METROPOLITAN GOVERNMENT OF NASHVILLE AND DAVIDSON COUNTY

STAFF RECOMMENDATION 1601 Russell Street July 18, 2012

Application: New construction – rear and side additions and accessory building, Reduced setbacks
District: Lockeland Springs-East End Neighborhood Conservation Zoning Overlay
Council District: 06
Map and Parcel Number: 08313037800
Applicant: John Root, architect
Project Lead: Sean Alexander, sean.alexander@nashville.gov

A1 ARCHITECTURAL SITE PLAN
 SCALE: 1/16" = 1'-0"

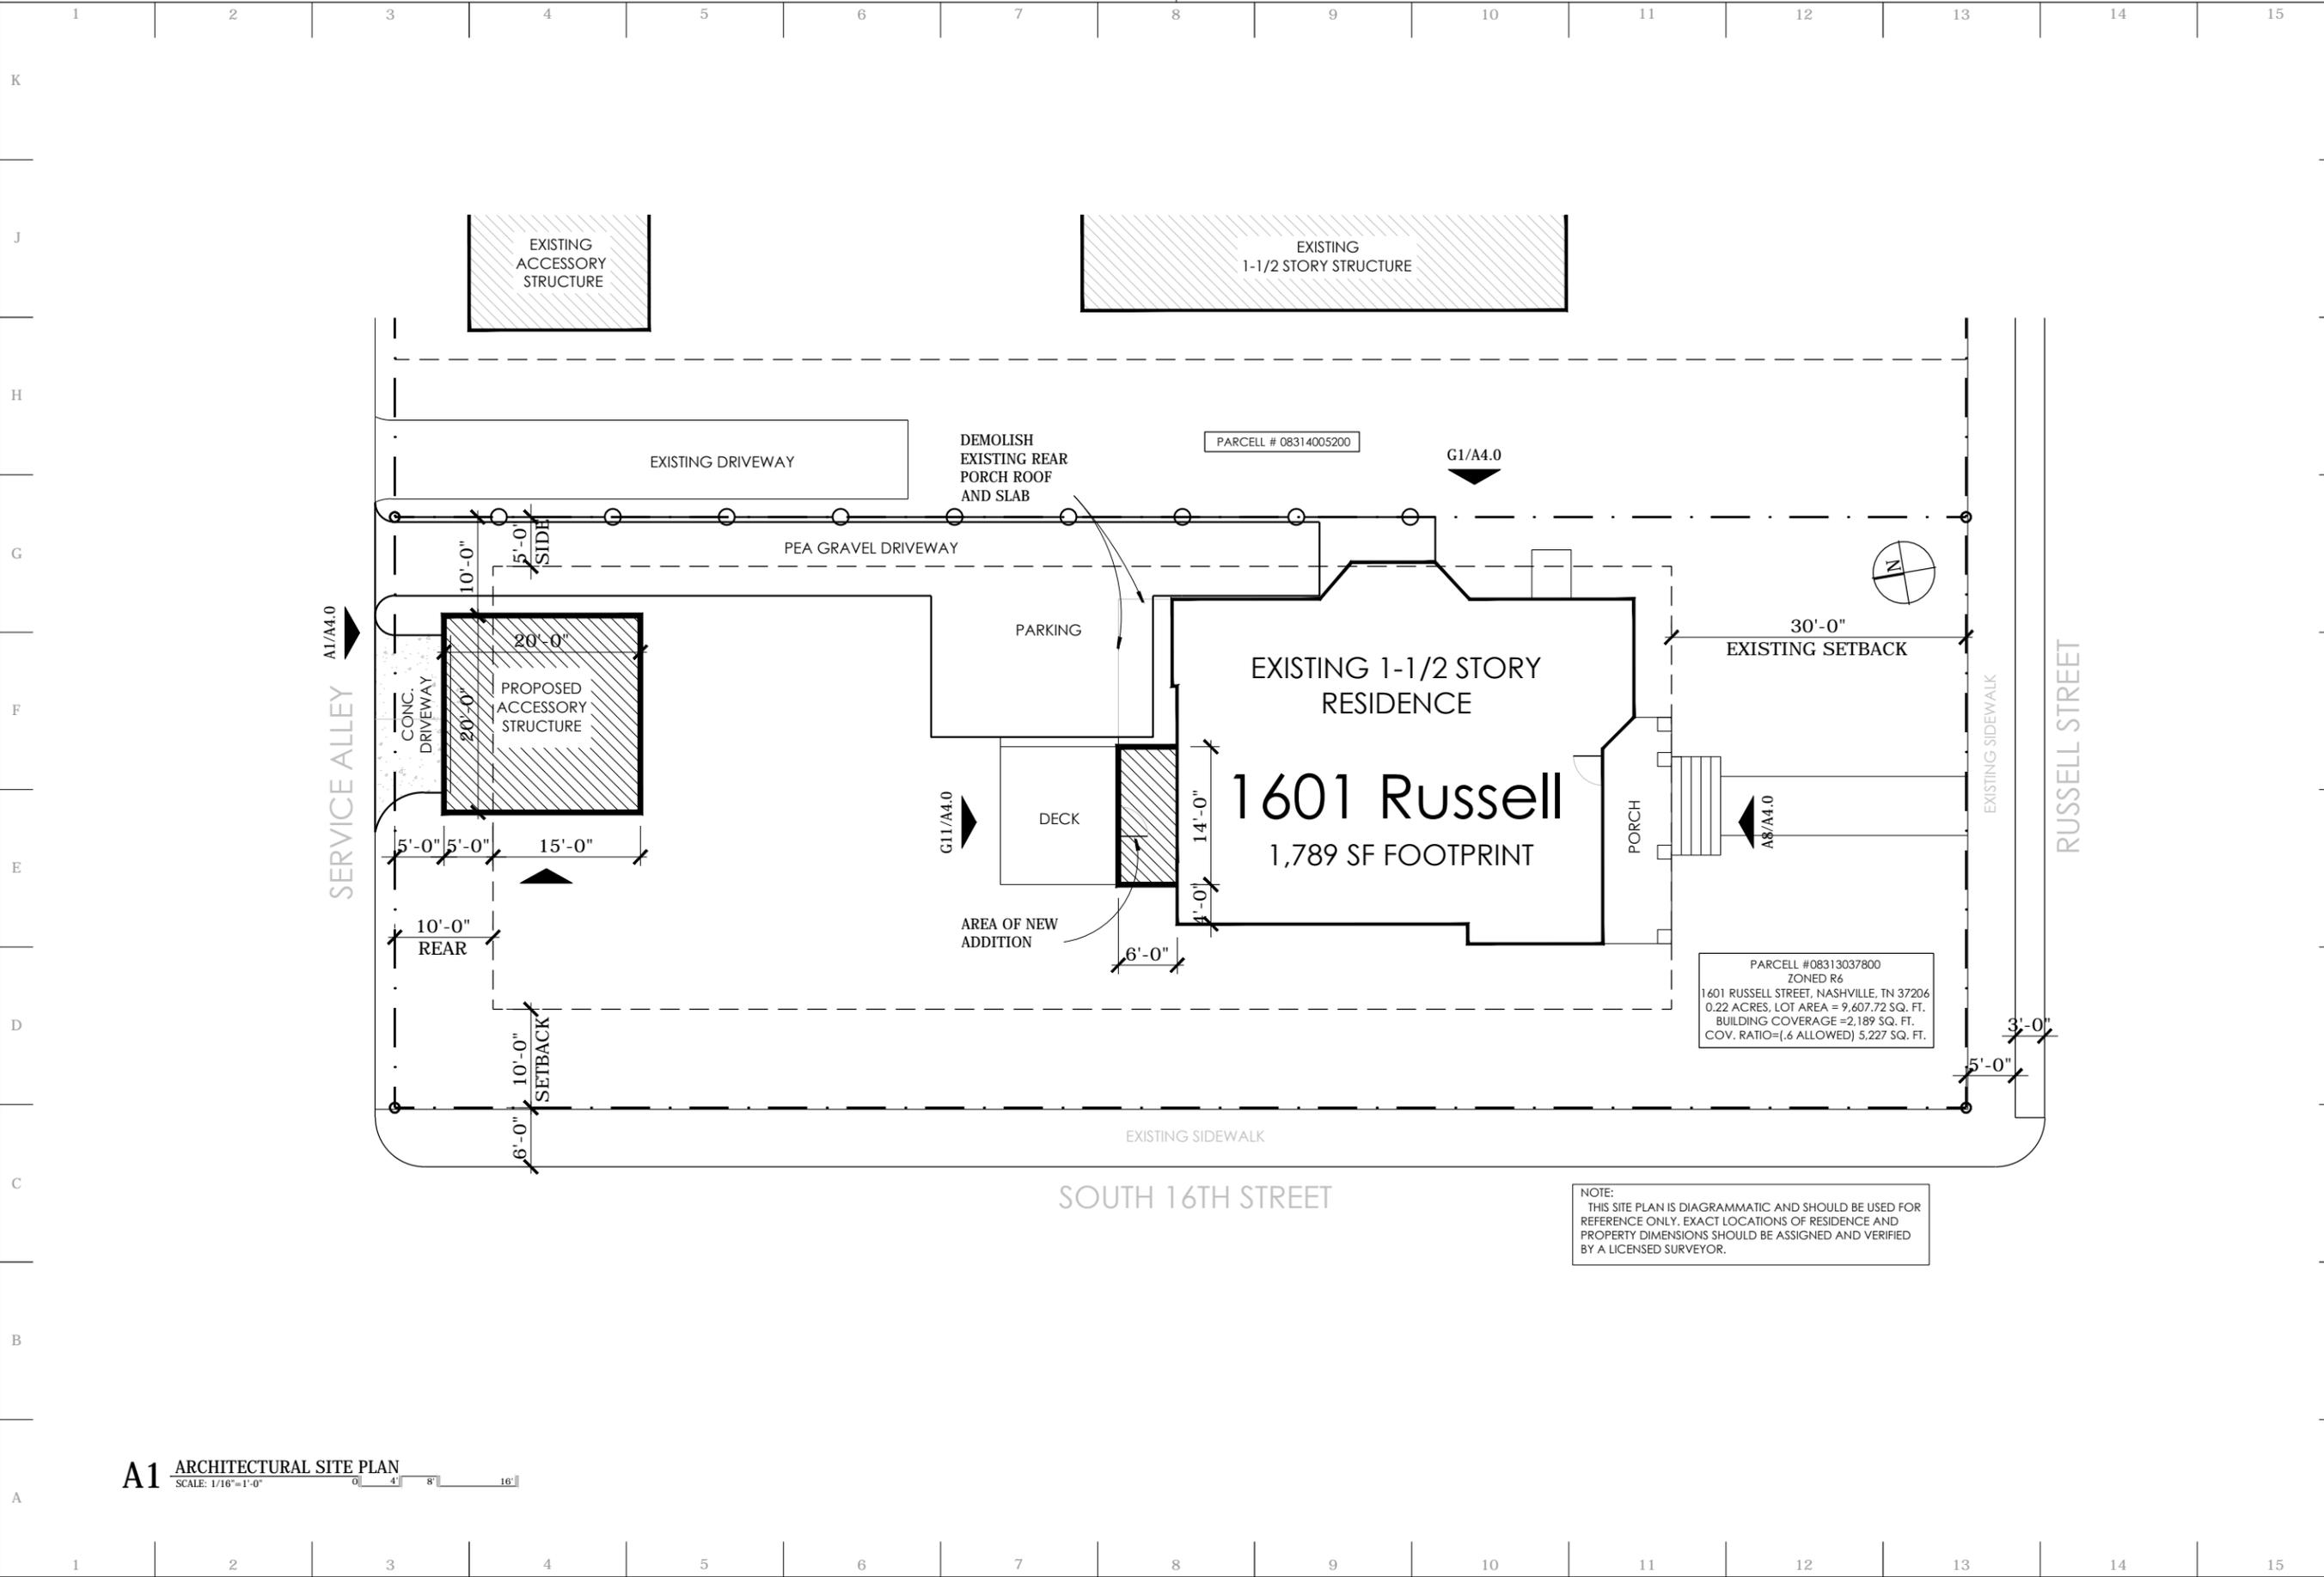
The new accessory structure is proposed to be located in the rear-right corner of the property, ten feet (10') from the right side property line and five feet (5') from the rear. For this location, the applicant is requesting a fifty percent (50%) reduction of the rear setback. Because the proposed location is in keeping with the typical location of historic accessory structures, staff finds it to meet guideline II.B.3 and II.B.8.

A new concrete apron will lead from the alley to the garage and a gravel driveway and parking pad is also being added from the rear alley to access the rear of the house. These are appropriate materials and locations for driveways and meets guideline II.B.9.

A1 REAR ELEVATION
 SCALE: 1/8"=1'-0" 0 1' 2' 4'

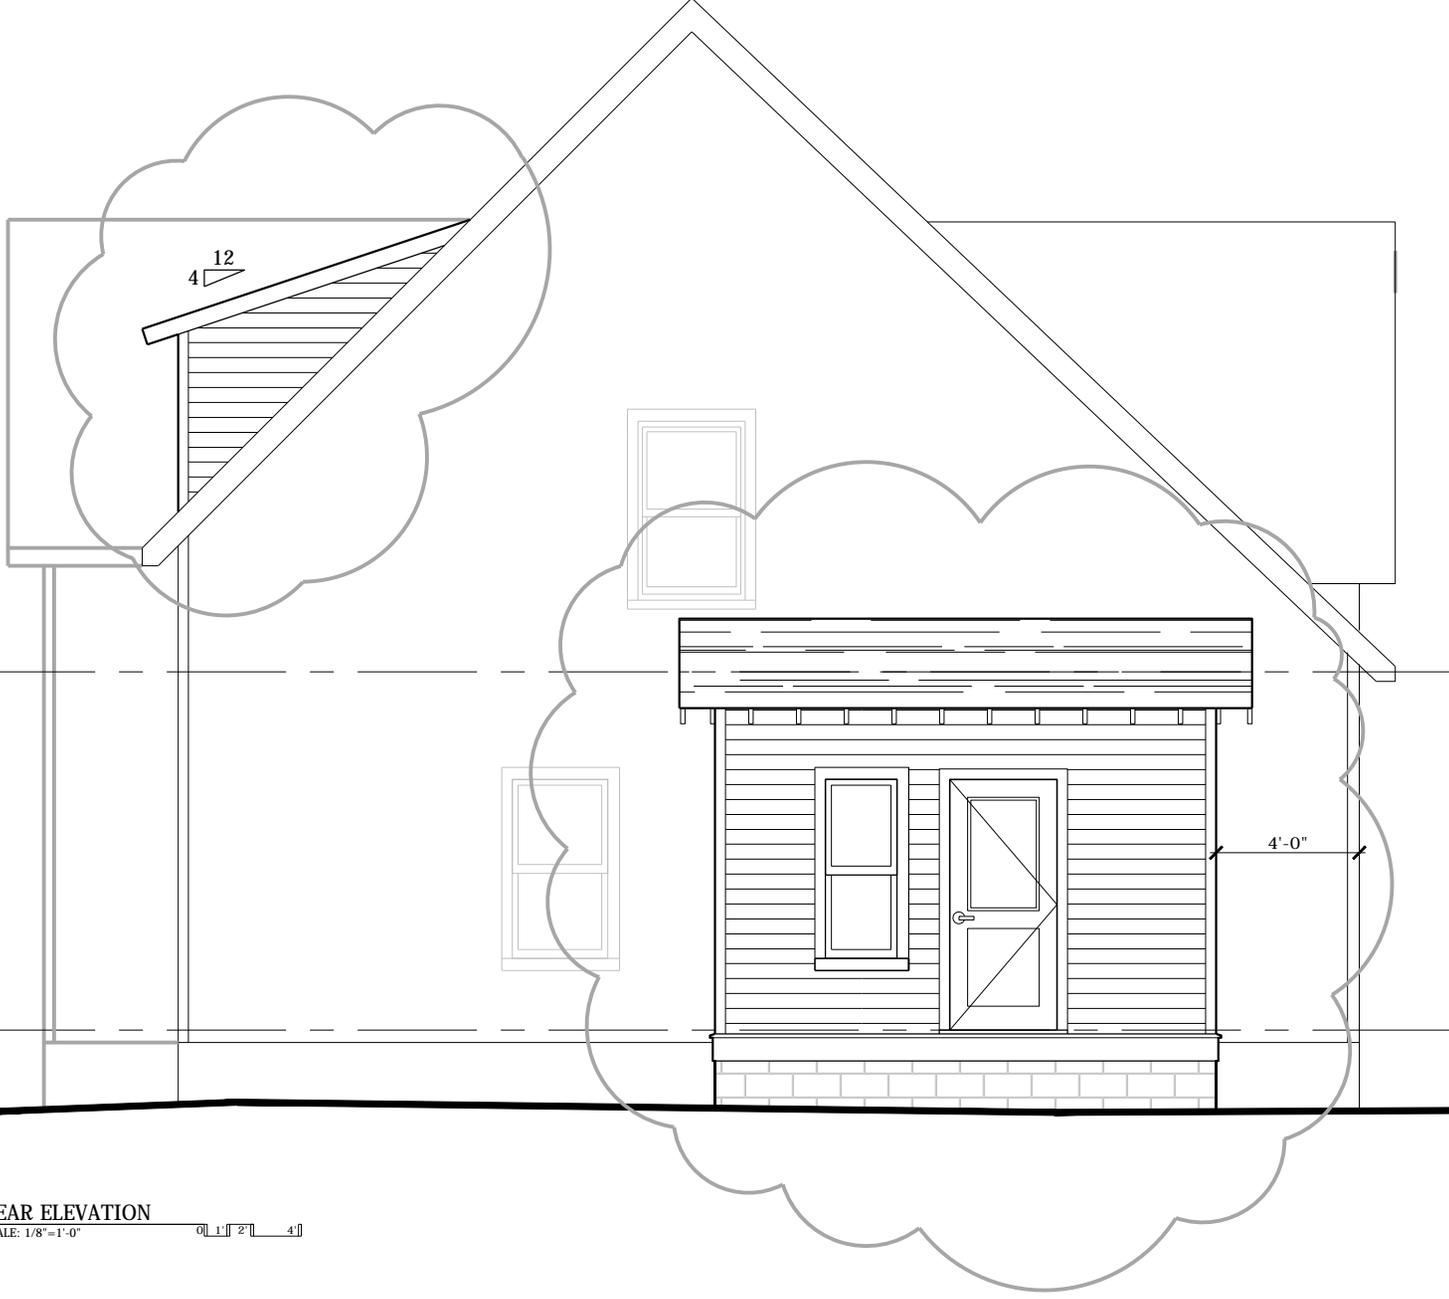
The footprint of the new rear addition will be eighty-four square feet (84') in area, roughly half the size of the existing rear porch. The addition will set in from the sides of the historic house by four feet (4') on the left side, facing South 16th Street, and by eleven feet (11') on the right. The rear addition will have a shed roof with a 4:12 pitch with an eave at eleven feet (11') above grade.

The roof of the addition will be a 4:12 shed, matching the height and location of the existing porch roof. The foundation of the addition will be six inches (6") lower than the house foundation, allowing for there to be a trim band at the floor level matching the floor level of the house. The rear wall of the rear addition will have a single door and a window, matching the size and maintaining the existing rhythm of openings on the house.

Recommendation: Staff recommends approval of the side dormer addition, rear addition, and new accessory building with the conditions that:

3. The applicant submit final material and design specifications for the windows of the additions, vehicular and pedestrian doors;
4. Staff shall approve the roof color

A1 ALLEY ELEVATION
SCALE: 3/16"=1'-0"

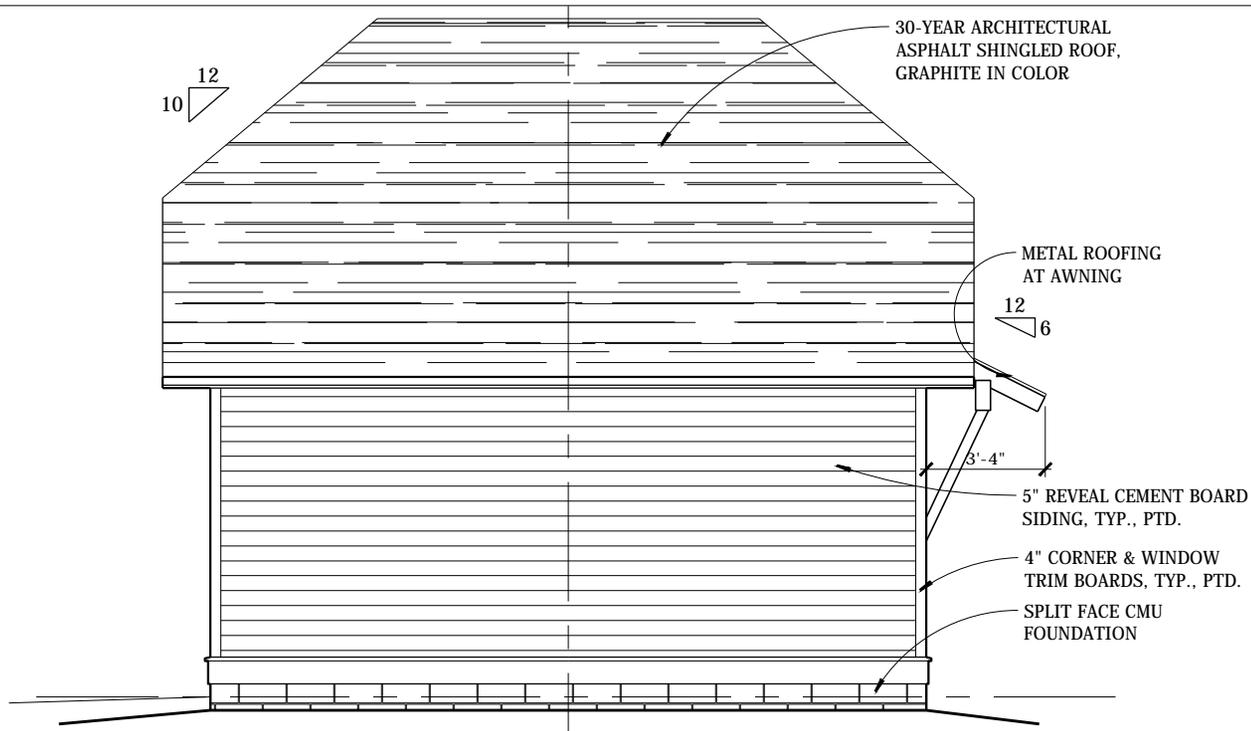
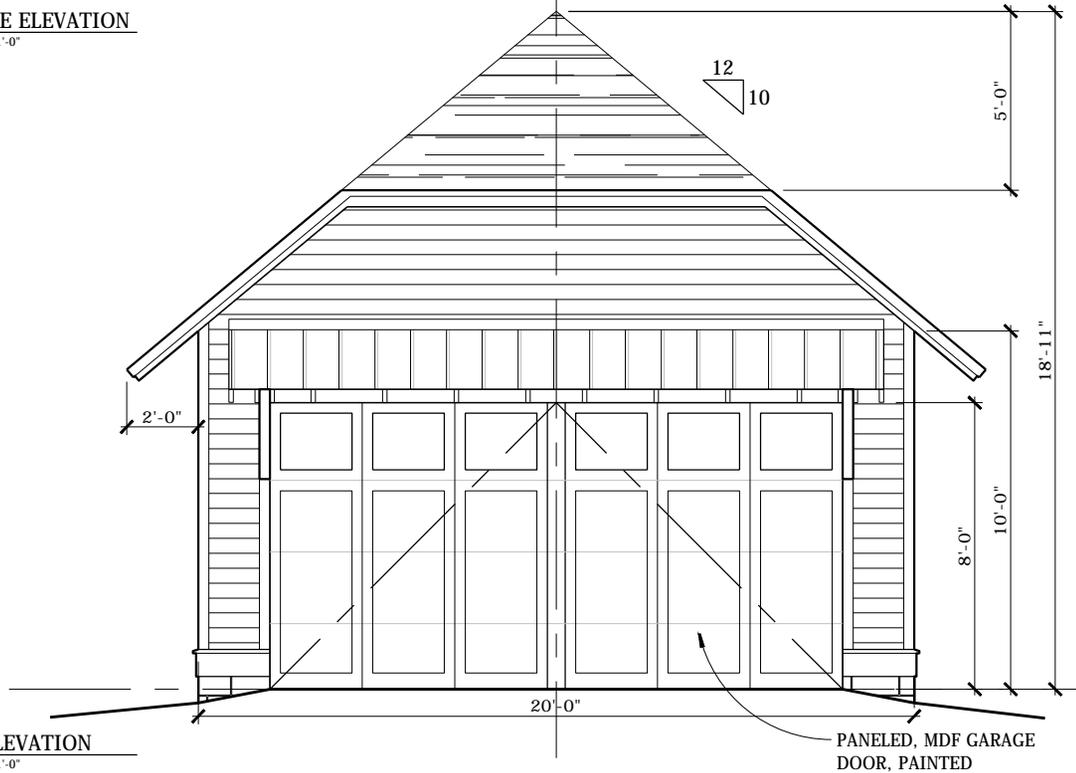
The new accessory building will be one-story tall with a peak at nineteen feet (19') with an eave height of ten feet (10') above grade. The structure will have a four hundred square foot (400 sq. ft.) footprint, a square with twenty feet (20') on each side. This scale is subordinate to the historic house and compatible with other accessory buildings nearby. The existing house is thirty-three feet (33') tall with a one thousand, eight hundred square foot (1,800 sq. ft.) footprint.

The materials of the two additions and the accessory building will be smooth cement-fiberboard clapboard siding with a five inch (5") reveal, wood trim and a fiberglass-asphalt shingle roof and the garage will have a metal roof awning. The foundation will be concrete slab. The additions will each have an aluminum-clad window, double hung on the rear addition and casement on the dormer, which are approved for new construction and additions in the overlay. The applicant will need to submit final material and design specifications for the windows of the additions, vehicular and
